STAFF REPORT 02-12-2025 REGULAR MEETING

APPLICATION NUMBER: HDC2025-00036

ADDRESS: 808-816 VIRGINIA PARK

SCOPE: ERECT MULTI-FAMILY DWELLINGS

Site plan (above) and perspective rendering (below) from the applicant's submission materials. The buildings will be faced in a mix of traditional brick and cement panels, as depicted below.

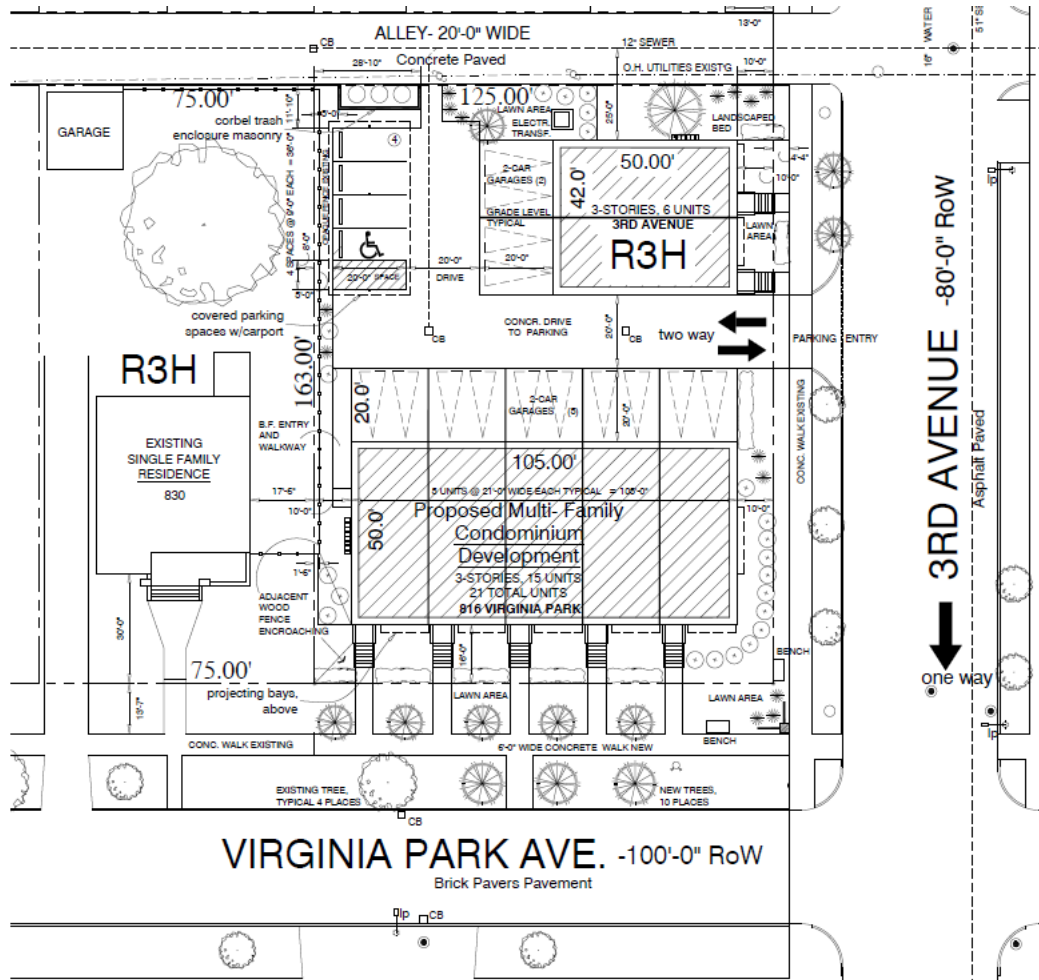
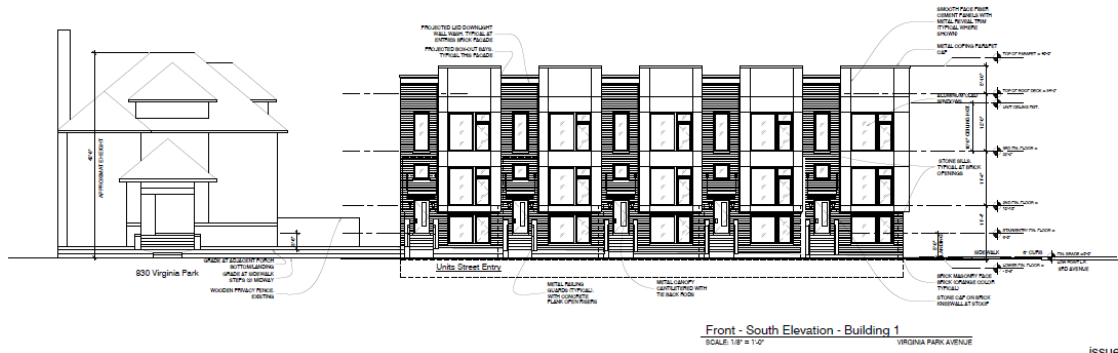
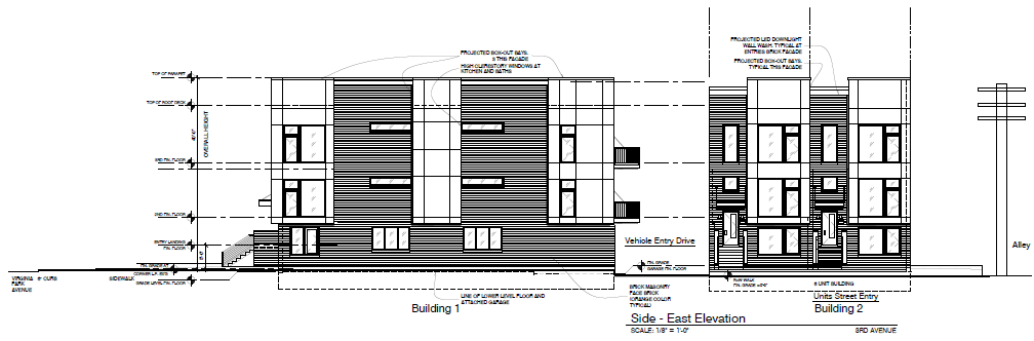
- **HDC Staff analysis:** The historic character of Virginia Park is universally single-family dwellings, with no historic terraces, rowhouse, or apartment buildings. As such the proportion of the front façade should appear taller than wide or wider than tall, with an overall neutral appearance. The proposed attached dwellings are substantially wider than tall, very far from neutral, and therefore fail this Element.

- **HDC Staff analysis:** The applicant characterizes the cement panels as “siding.” Staff disagrees. Unlike the brick, cement panels with metal reveal trim are not reasonably related to a historic material precedent on Virginia Park Avenue. While modern materials on new construction in historic districts are often used successfully in small doses (as accents), especially when they can be traced to a historic use, the extensive use of modern panels on these proposed buildings makes them the default primary expression and substantially at odds with the historic context. This element is failed. See also Element 8, below.

- **HDC Staff analysis:** Though lack of architectural details is often a feature of contemporary design, in this case the Elements specifically call out the “more ornate” character of Virginia Park Avenue in the City Code. There are ways to imbue contemporary designs with ornate character while staying true to a modern style, which should be explored further by the architect. New construction on this street, independent of style, should continue to exhibit the special character of Virginia Park, in texture, material, and detailing. This element is failed.

- **Applicant response:** The flat roof is less complex than other homes and is appropriate to the contemporary style of the building.
 - **HDC Staff analysis:** Staff agrees that flat roofs are appropriate to the contemporary style of the proposed building; however, flat roofs are not compatible with the existing character of Virginia Park, which is universally marked by pitched and complex roof forms of various types. Contemporary design, as suggested in Element 10 above, is flexible enough to incorporate complex geometries and intricate details while staying true to a modern “style.” These ideas should be further developed. This element is failed.

- **HDC Staff analysis:** The conceptual design for the townhouses at 801 Virginia Park, as published by PDD in the Rosa Parks/Clairmount Neighborhood Framework Plan, was not intended to meet historic standards and prioritized the provision of affordable housing. Should that design be adopted or developed, with additional community input, it would be presented to the Commission for consideration under a Notice to Proceed as a substantial community benefit. The same limitation exists here. Under historic standards concerning walls of continuity and consistent setbacks, this Element is failed.

- **Applicant response:** The apartment buildings have a moderate scale facades with small scaled elements.
 - **HDC Staff analysis:** Staff assesses that the scale of the facades in the proposal, while moderate, are not compatible with the scale/complexity of the facades on the historic buildings along Virginia Park. See also Elements 7 and 10. This element is failed.

- **Applicant response:** The front facades are simple and less complex in keeping to the contemporary design style.
- **HDC Staff analysis:** Similar to discussion above, the precedent complexity of the existing houses on Virginia Park requires a similar complexity in a historically compatible new structure, independent of the style. New construction should not appear sparse, plain, or stripped down. This element is failed.

- **Applicant response:** The character is strengthening by developing this
- vacant lot with urban, moderate density housing.
- **HDC Staff analysis:** The proposal is not compatible with the general environmental character of Virginia Park Avenue, which is marked by large residences set off on lawns in a low density setting, each of them richly detailed. This element is failed.
